# TECHNICAL BULLETIN

## 030

### October 2021

- PUMP XLT HIGH TEMPERATURE WITH PLUNGER D22mm
- New low pressure seal Ø22 (pos. 7). New pressure ring Ø22 (pos. 6)
- The new low pressure seals are **NOT INTERCHANGIABLE** with the current one.
- Only restored complete seal packing (Pos. 5-6-7-8-9) **IS INTERCHANGEABLE** with current one (Pos. 5-6-7-8-9)

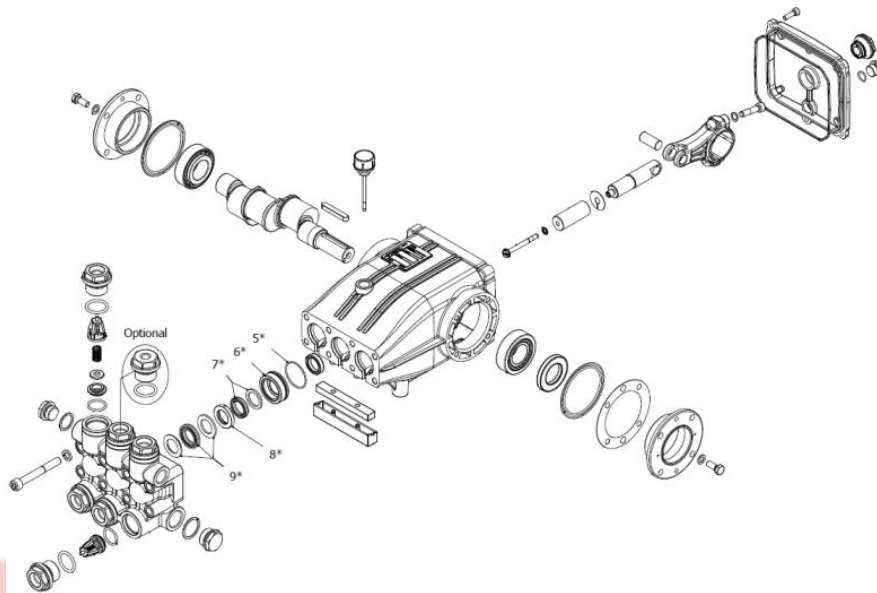
<b>CURRENT KIT</b>		<b>NEW KIT</b>	
<b>1.099-861.0*</b>	PLUNGER SEALS DIA. 22 mm	<b>1.904-918.0*</b>	PLUNGER SEALS Ø22 rev1 (XLT-XXT HT)
<b>1.905-855.0</b>	COMPLETE SEALS PACKING DIA. 22 mm	<b>1.904-919.0</b>	KIT GUARNIZIONI COMPLETO XLT HT 22 rev1

**\* NOT INTERCHANGIABLE**
